H. Chaffinow Homes Inc CO, Falcon - CUH003020 - PM at Bent Grass FUSION2-Plant/ECQ/H20 P 04.0 Cover Sheet/Draw - Bent Bridge - 12/4/2022

EARLY GRADING & EROSION CONTROL PLANS
FALCON MEADOWS AT BENT GRASS FILING NO. 3
FOR
CHALLENGER COMMUNITIES, LLC

EROSION CONTROL
DETAILS

MATCHLINE SHEET G1.1

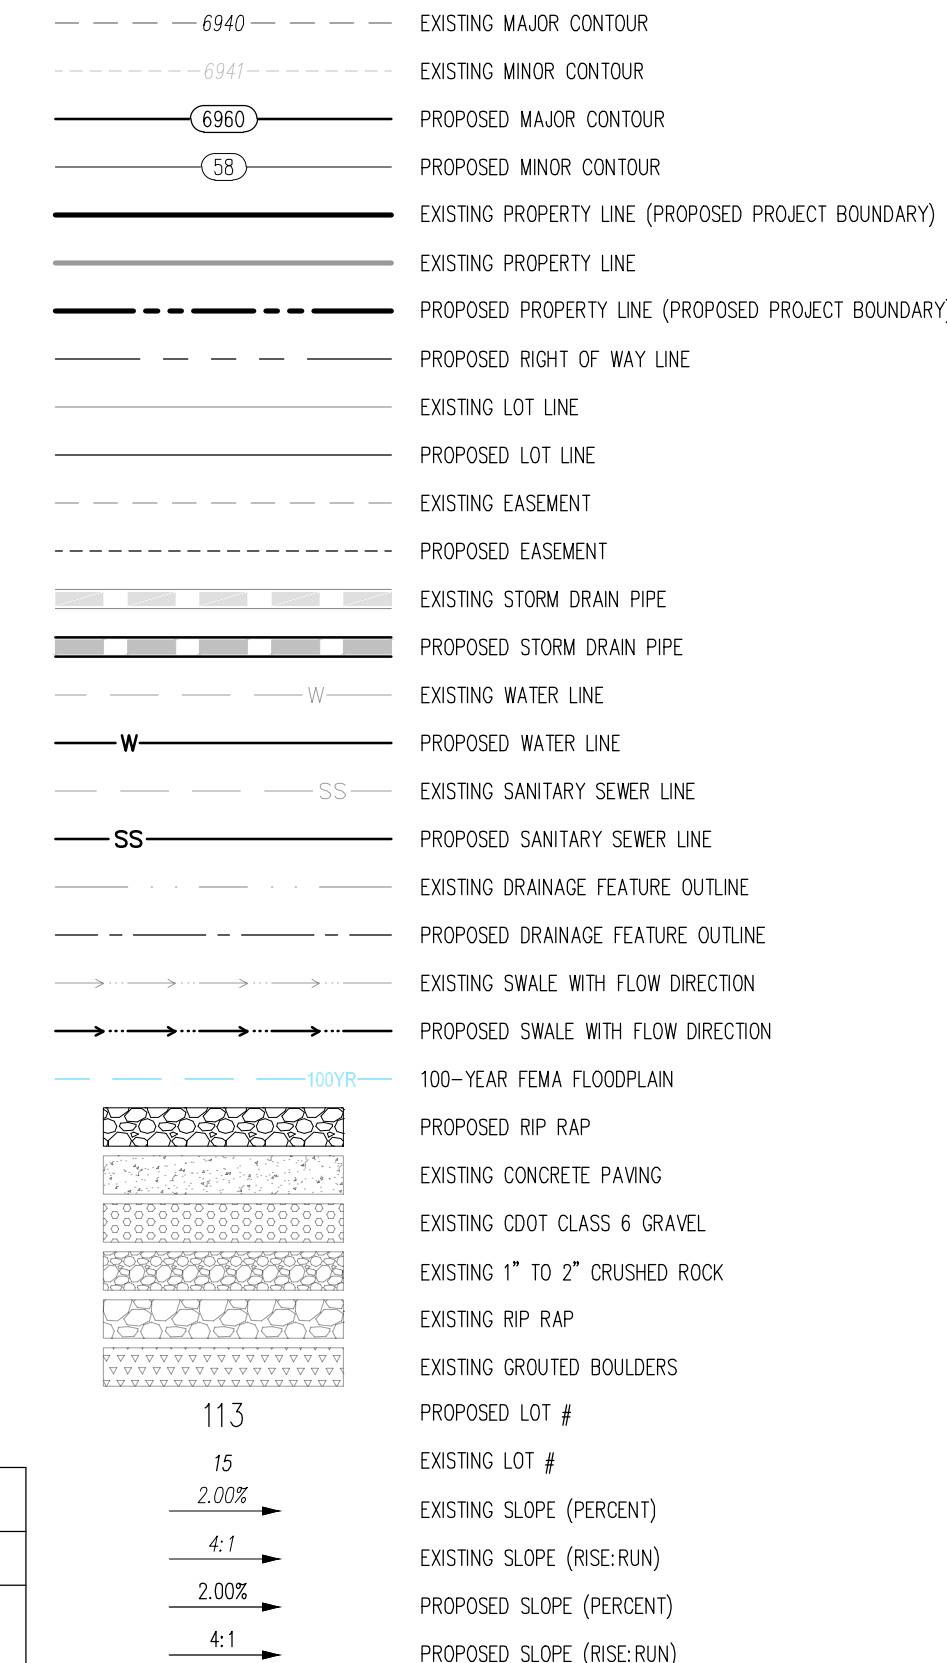
Show existing storm sewer and inlets and provide the appropriate protection.

show existing storm drains
and inlets so IP can
appropriately be shown.

EX. STORM AND INLET
PROTECTION ARE VISIBLE

EX. STORM AND INLET PROTECTION ARE VISIBLE

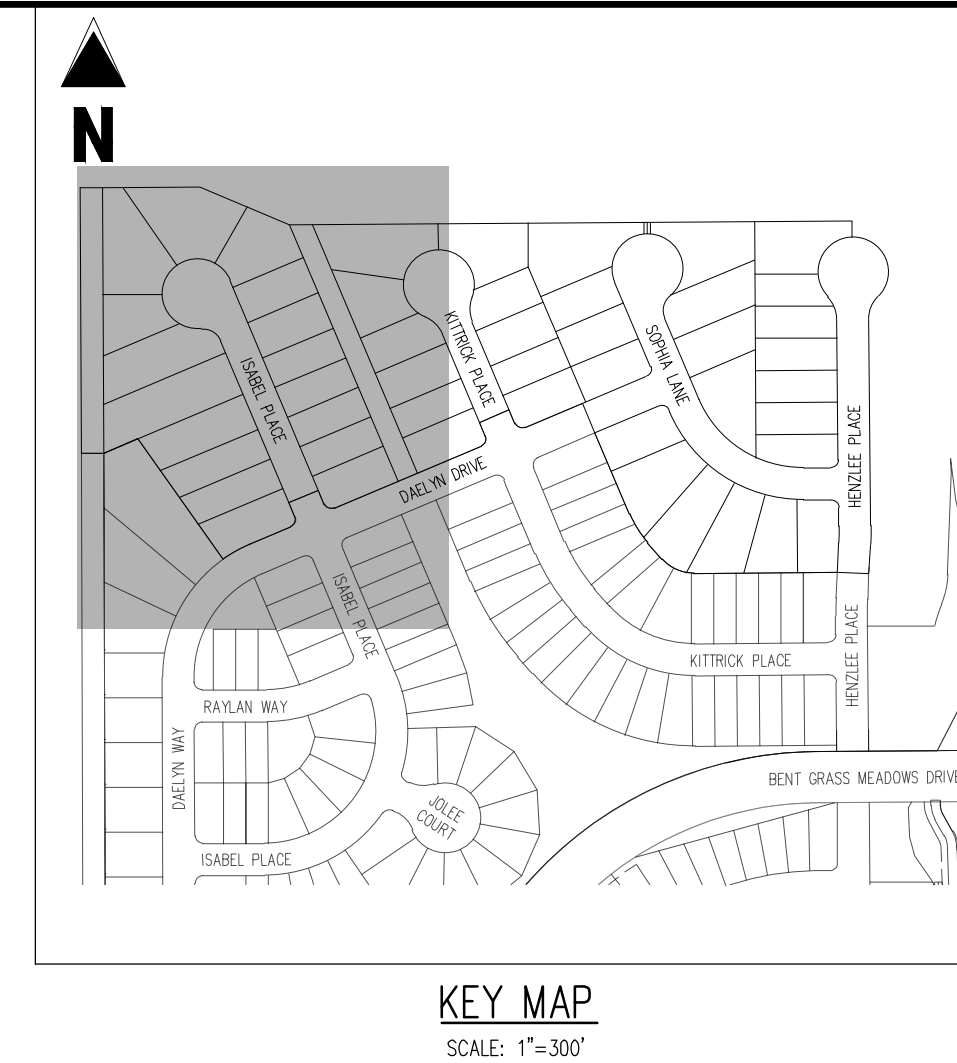
show existing storm drains and inlets so IP can appropriately be shown.

Show location on plans.

EX. STORM AND INLET PROTECTION ARE VISIBLE

TEMPORARY SEDIMENT BASIN IS PLACED

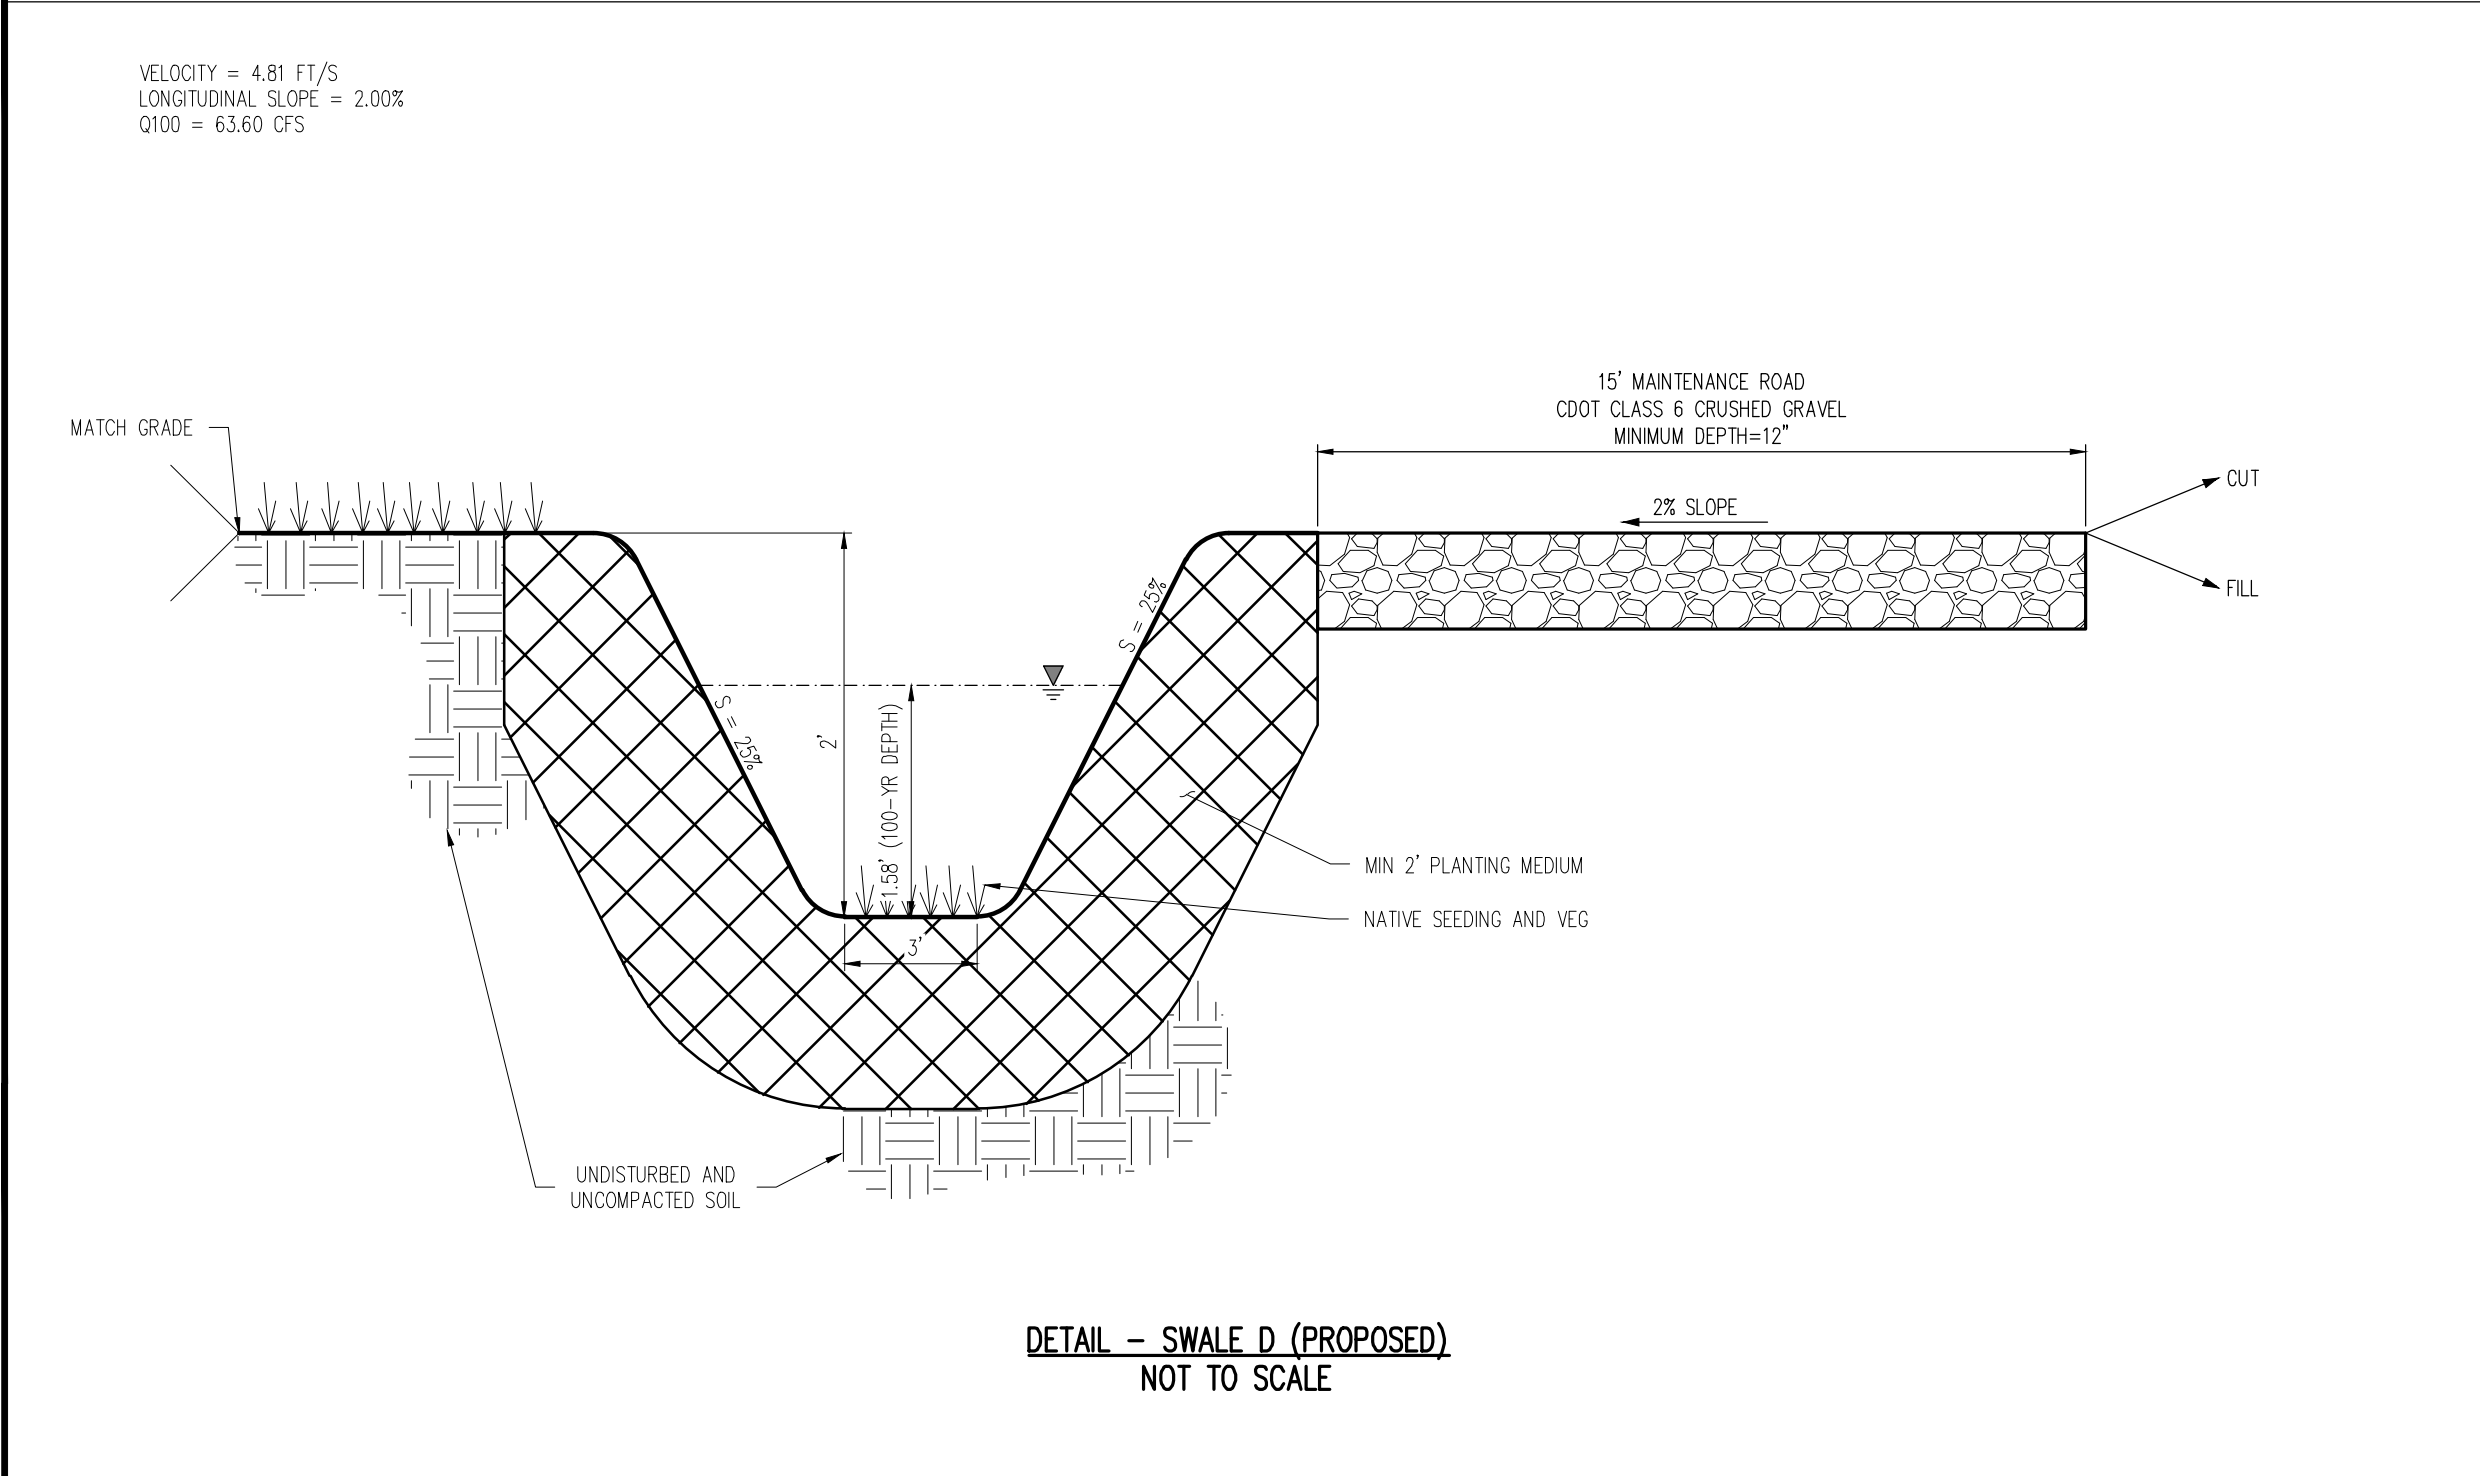
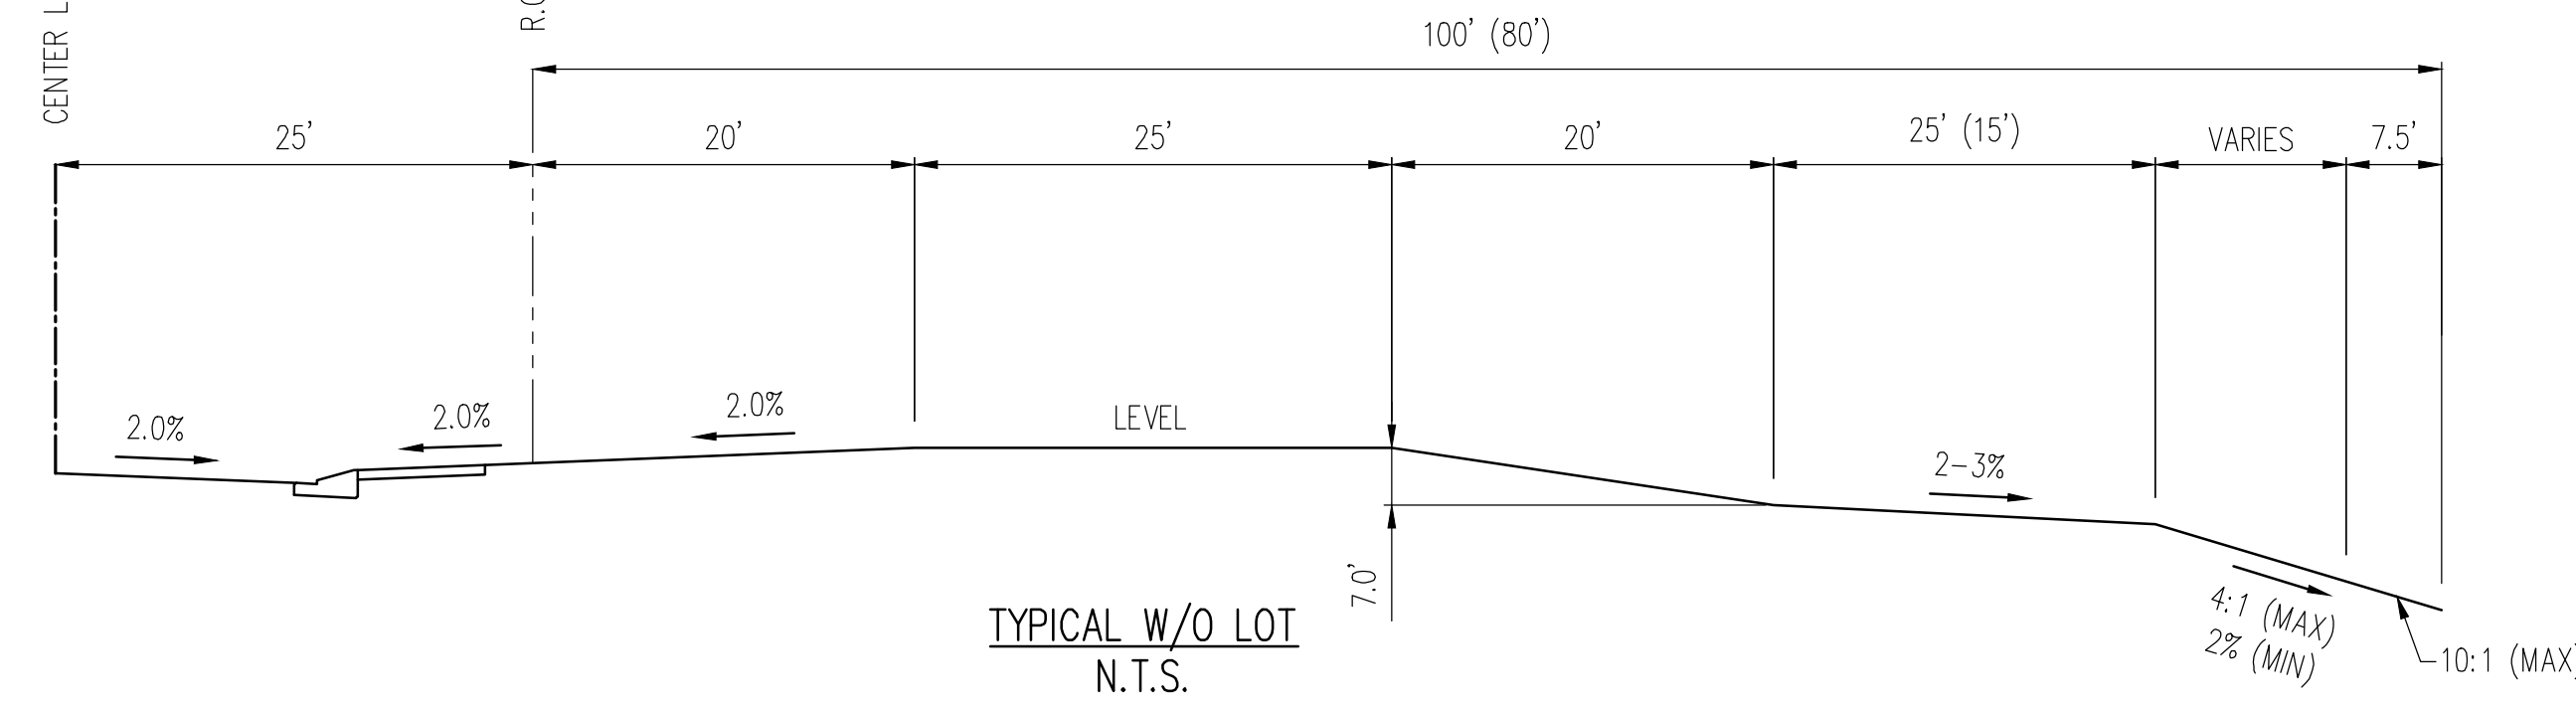
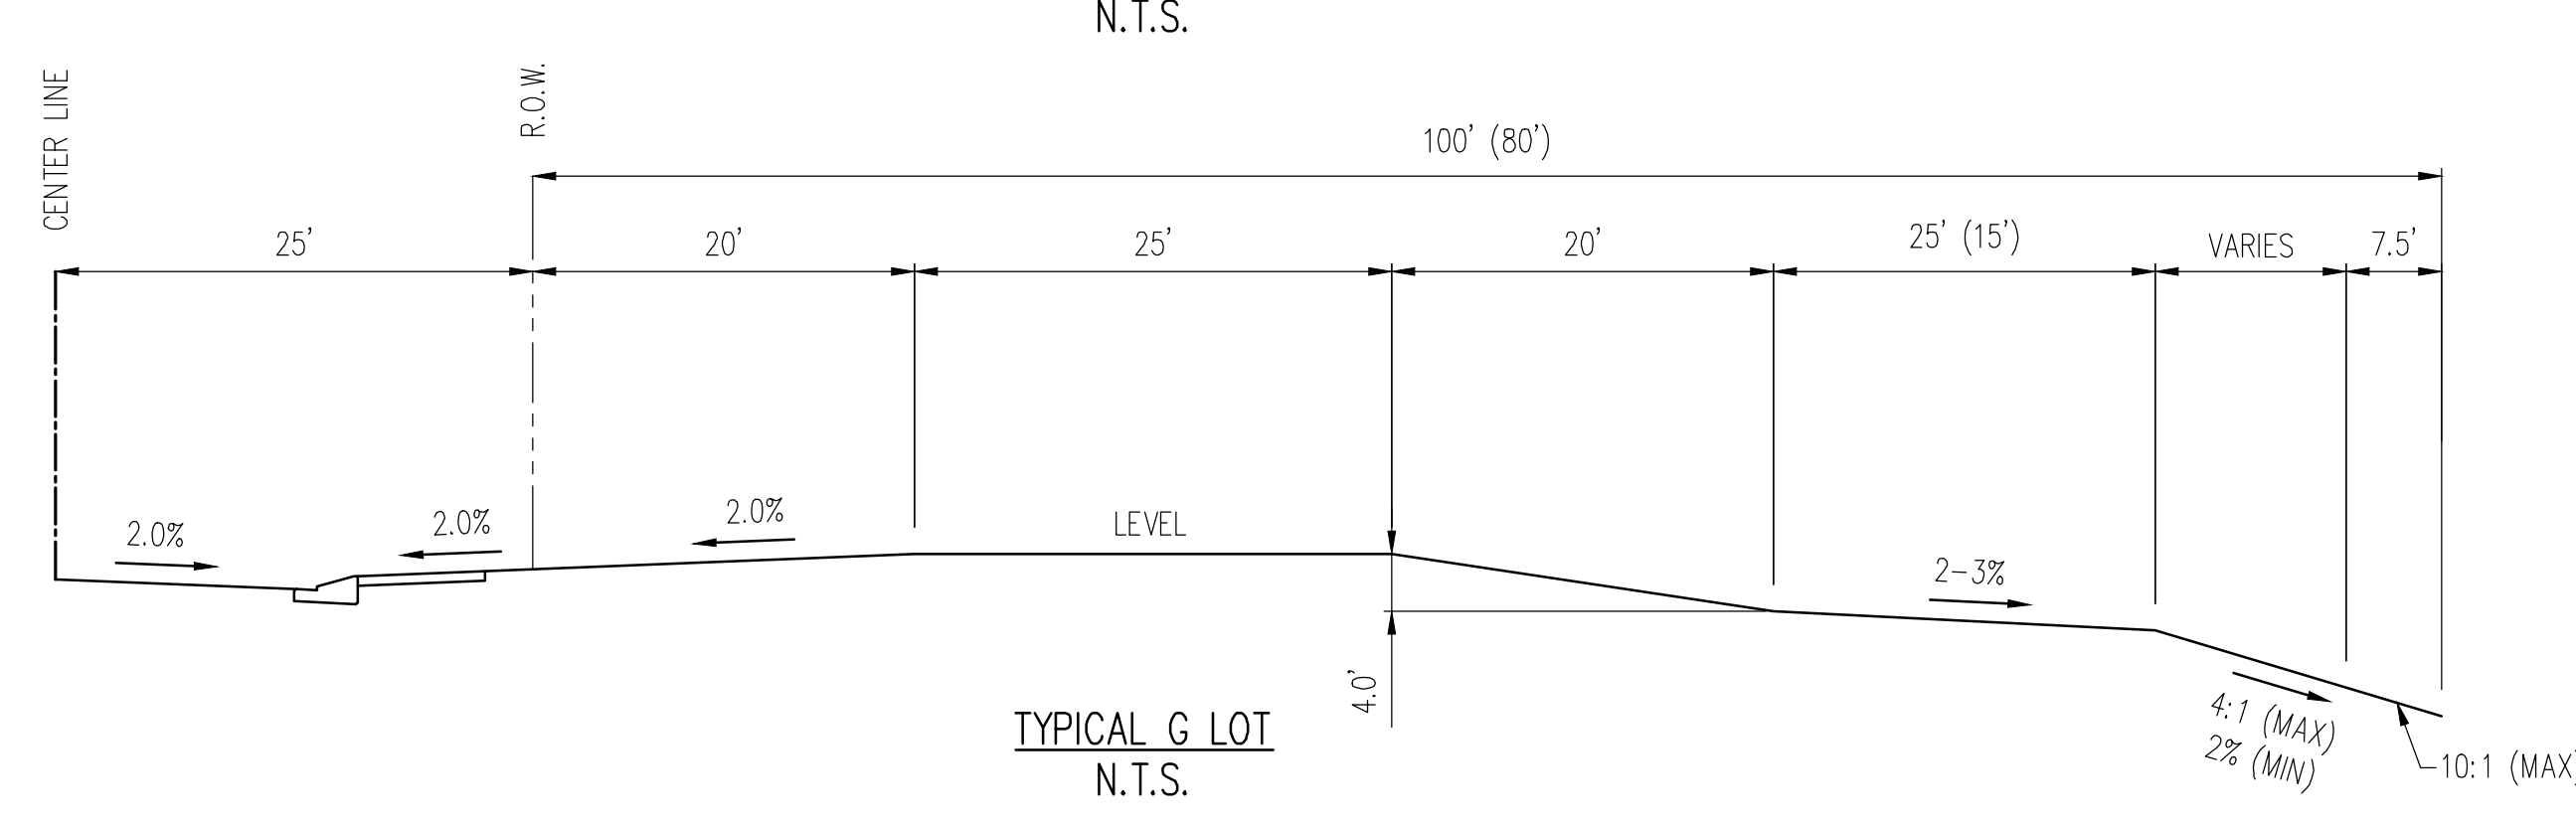
Provide cross section label for the proposed swale D

Alot of the runoff from the proposed development on this sheet (about 2-3 acres) is tributary to this point. Per pg 24 of the SWMP text, all flows from F3 will be conveyed to the existing North and South ponds.

I am concerned about the subsequent mess of sediment between this point and the South Pond. The runoff has to travel a long way along the road and/or storm drains to get to the pond, which will mean sediment deposits throughout the C&G and UG pipes. And the only protection upstream is 3 straw bales and 3 rock socks. Consider the need for onsite TSB(s) and/or sediment traps.

This is a typical comment for the previous sheet as well (except the areas are different sizes and are trib to the North Pond).

CROSS SECTION LABEL IS PRESENT

SEDIMENT TRAPS AND CONSTRUCTION FENCE PLACED IN SWALE FLOW LINES AND VTC REDUCED TO 20' WIDTH
